**APPLICATION FOR CERTIFICATION 07-AFC-7  
SUPPLEMENT A**

**KRCD COMMUNITY  
POWER PLANT**

Re: Supplemental Information in Response to CEC Data Adequacy Request for the Kings River Conservation District Community Power Plant Application for Certification (07-AFC-07)

**KINGS RIVER CONSERVATION DISTRICT COMMUNITY POWER PLANT  
APPLICATION FOR CERTIFICATION (07-AFC-7)  
SUPPLEMENT A**

FIGURE: 1-3 Rev.1  
**KRCD CPP Project Area**  
Page: 1 of 9

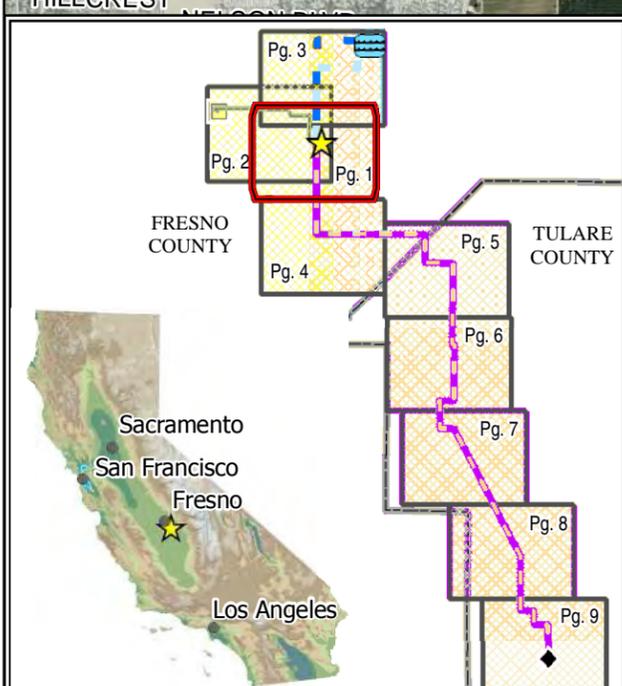
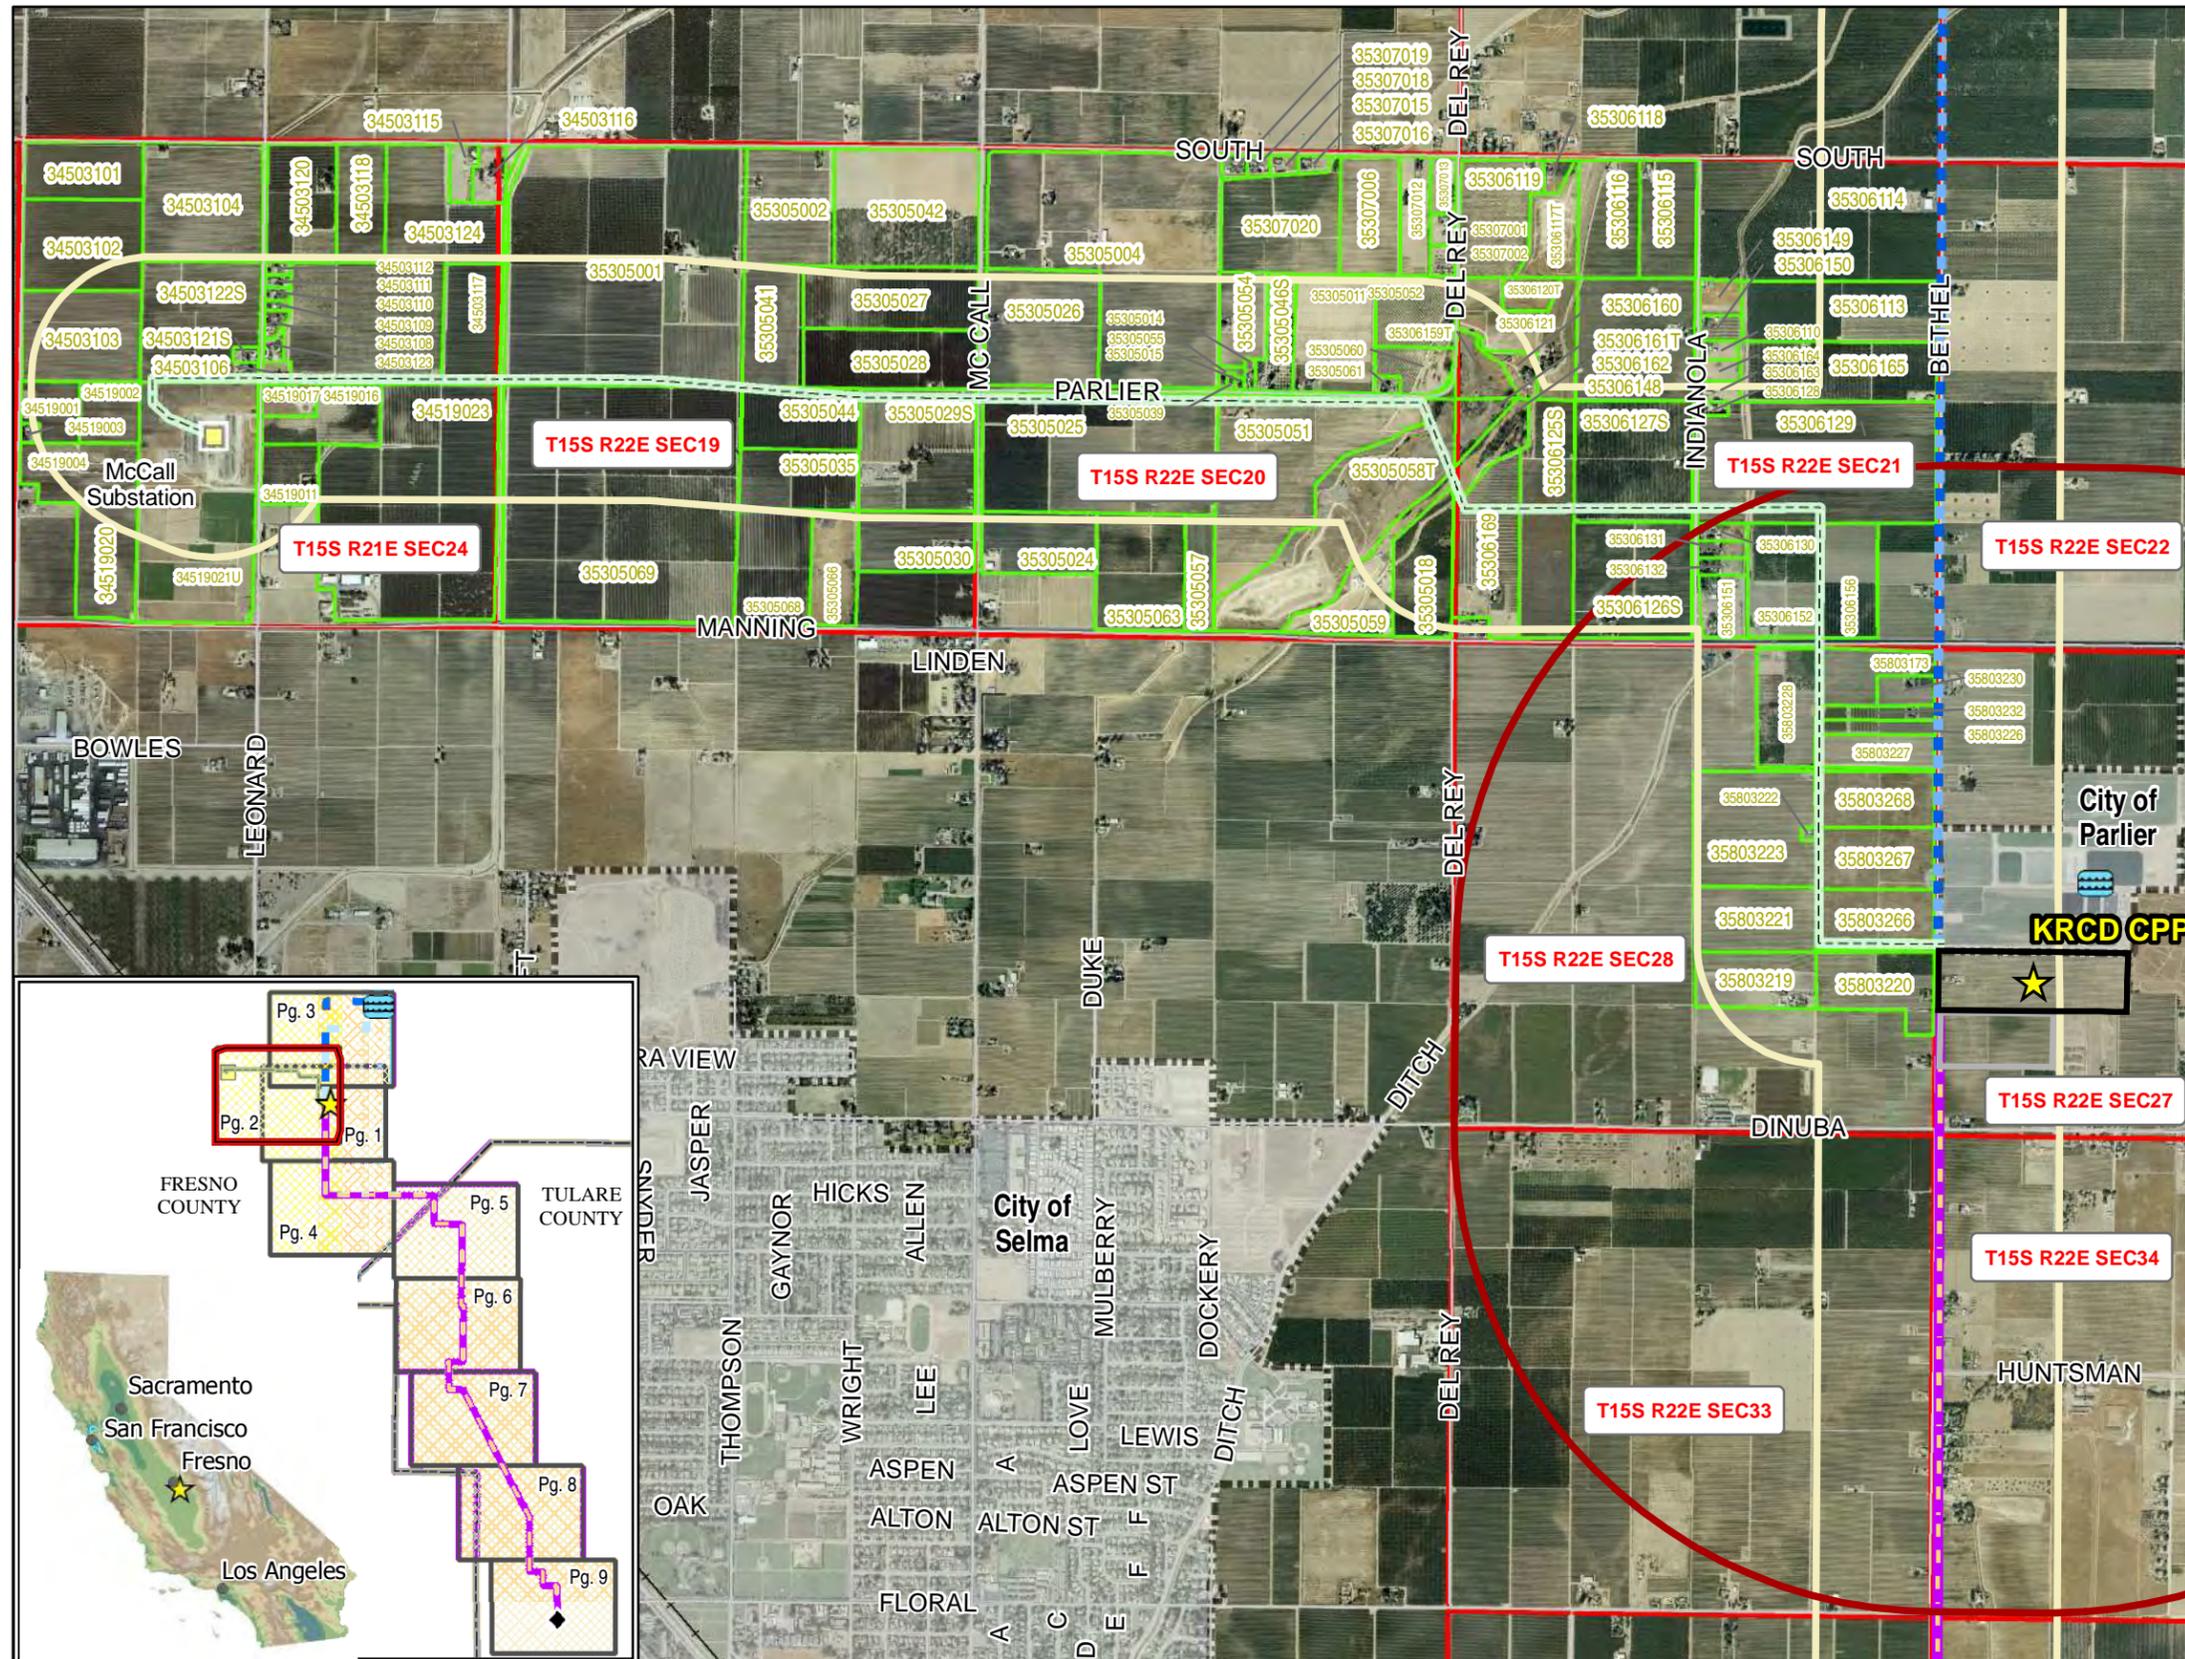
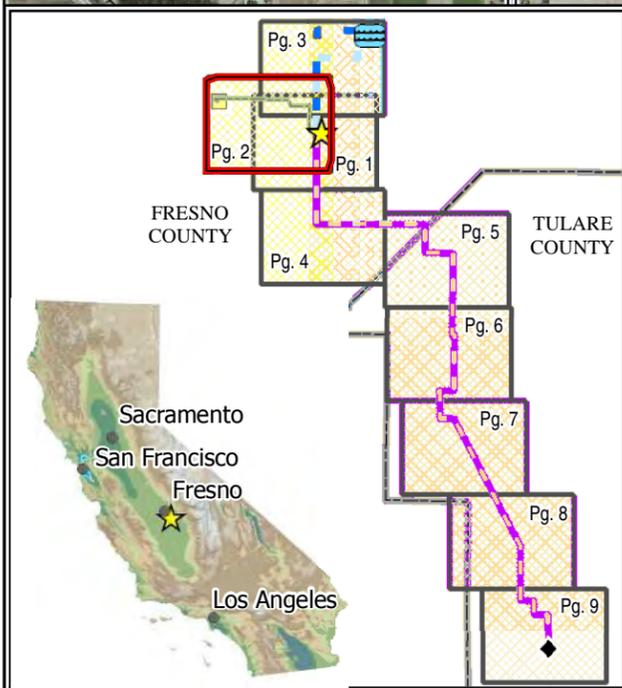
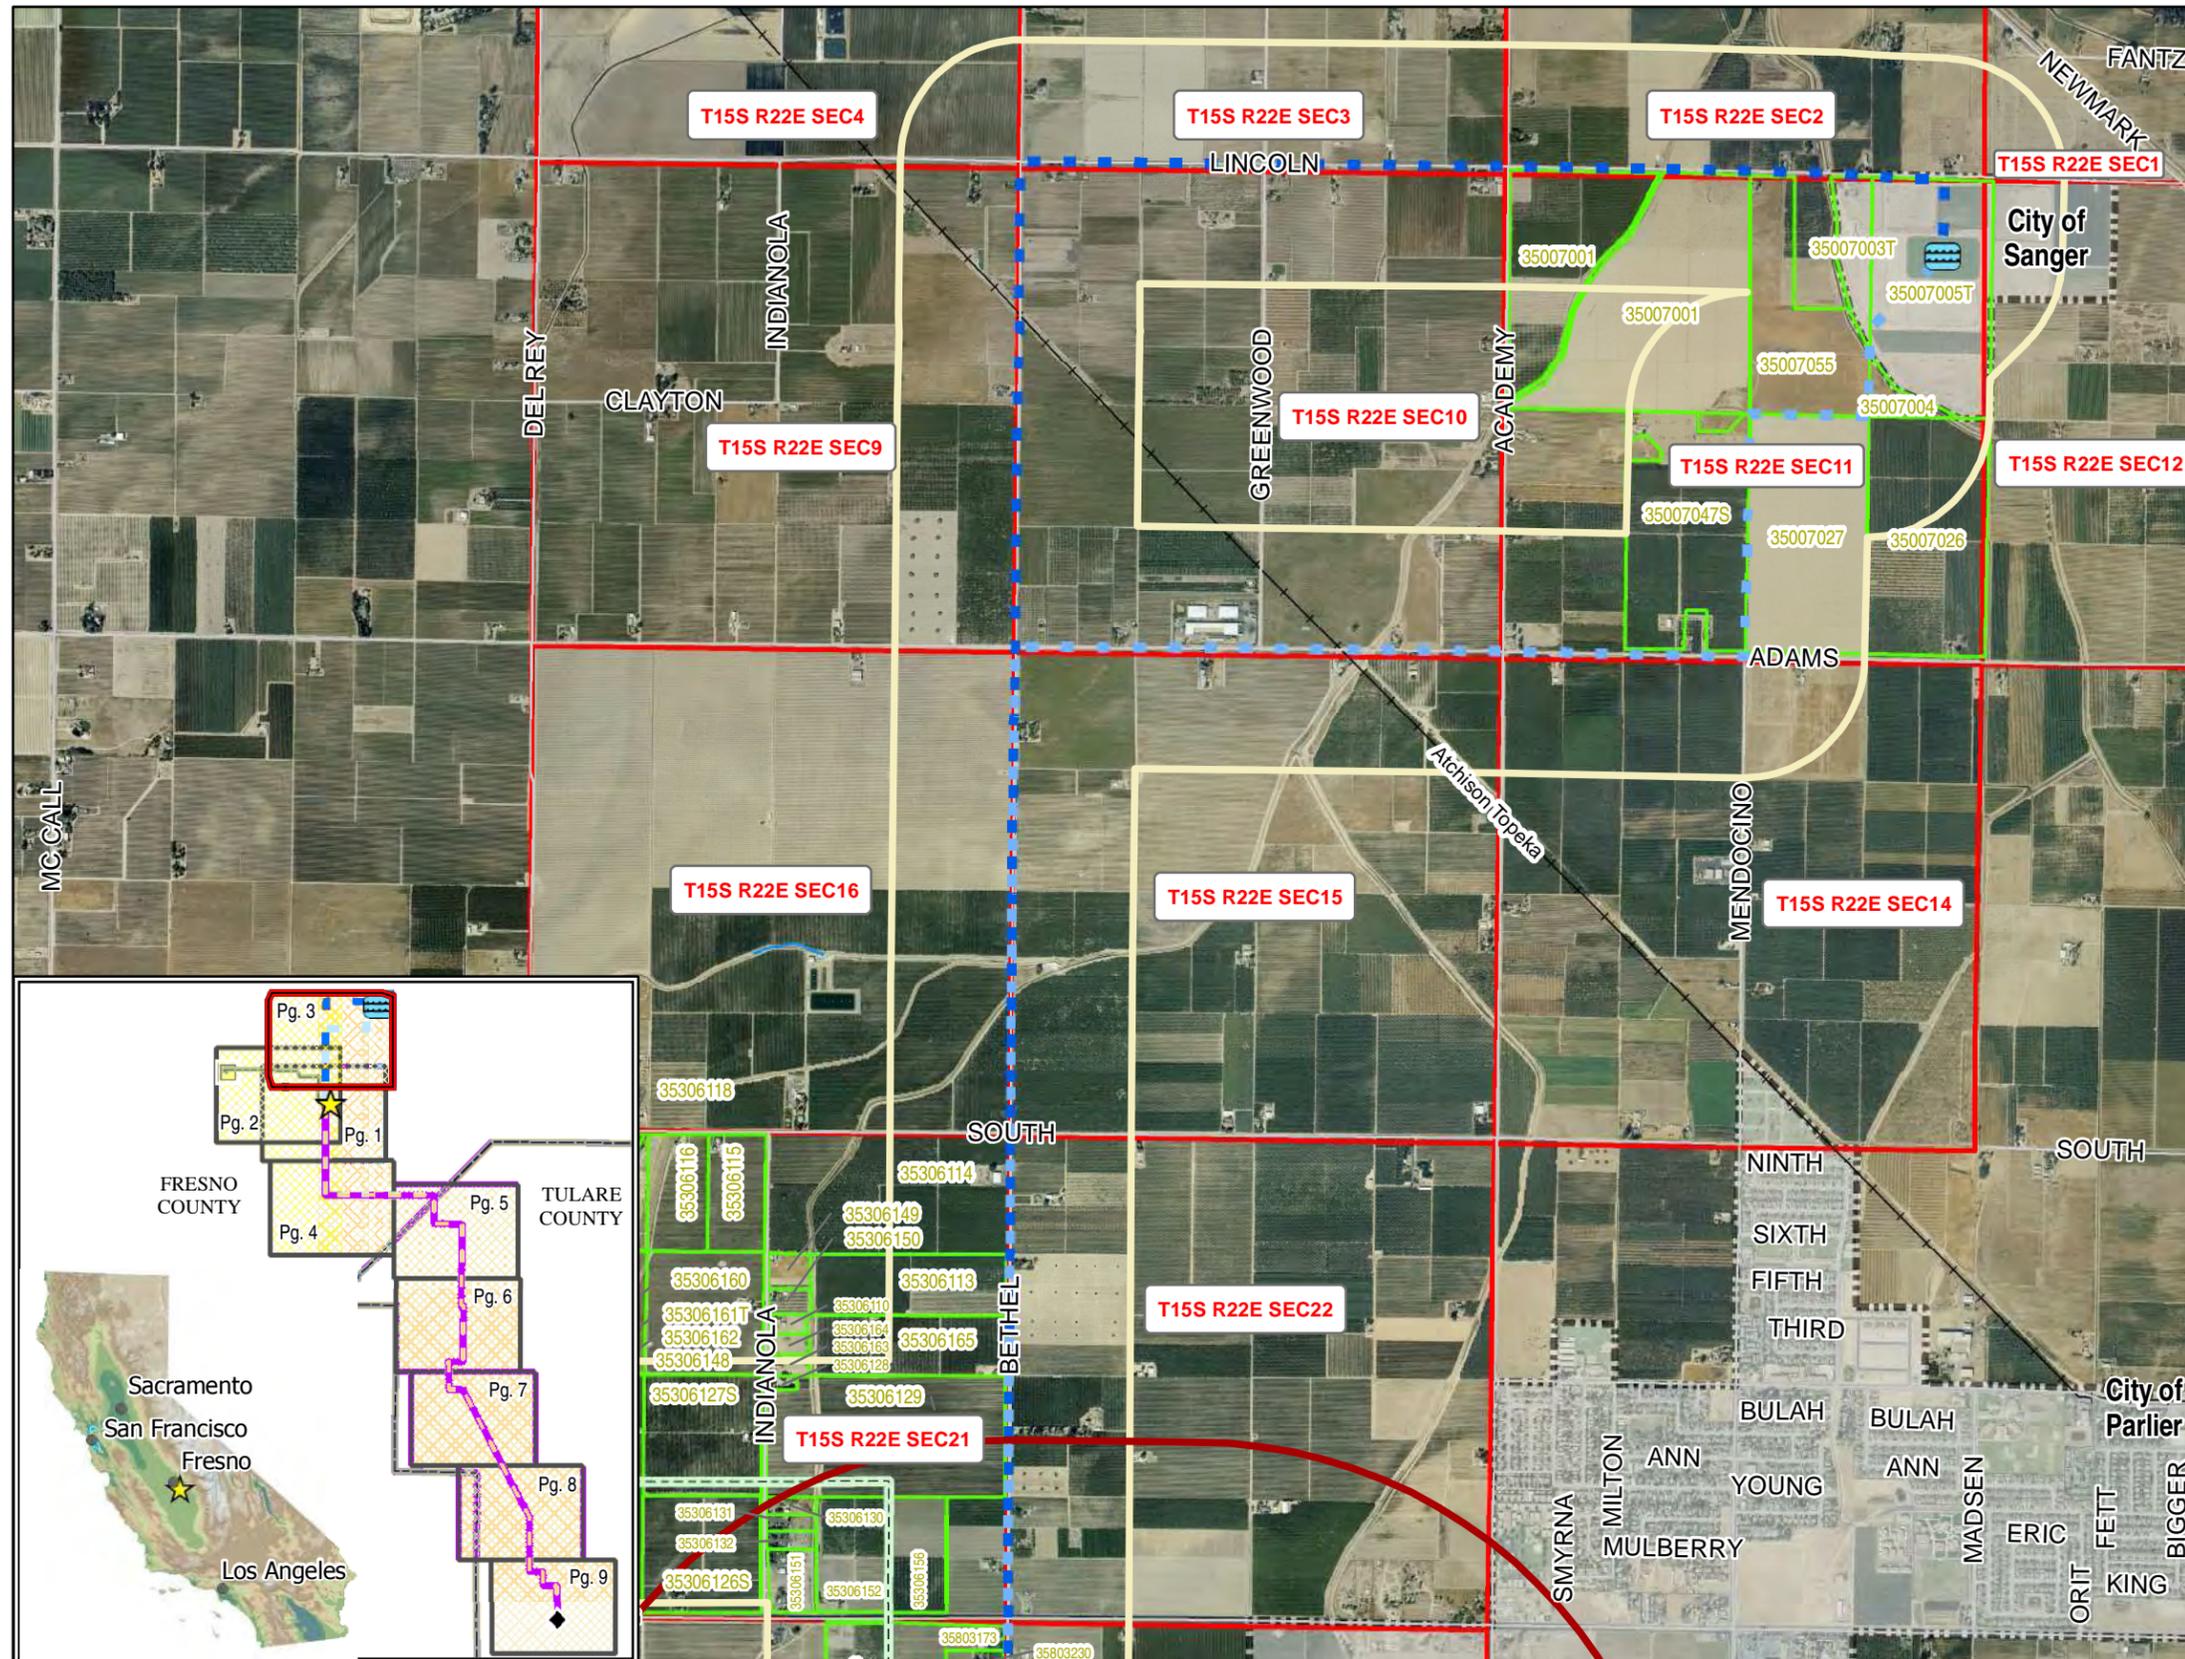
Provide the section, township, range, county, and county assessor's parcel number for the proposed water, gas, or transmission interconnection routes.

Included as Attachment PO-2, are revised Figure 1-3 - KRCD CPP Project Area and revised Figure 2-7 - KRCD CPP Site and Land Description. The revised figures include applicable section, township, and range information as well as the county assessor's parcel numbers for areas where the KRCD CPP project area crosses private property. The attached revised Figures 1-3 and 2-7 should replace Figures 1-3 and 2-7 in KRCD CPP AFC Volume 3.
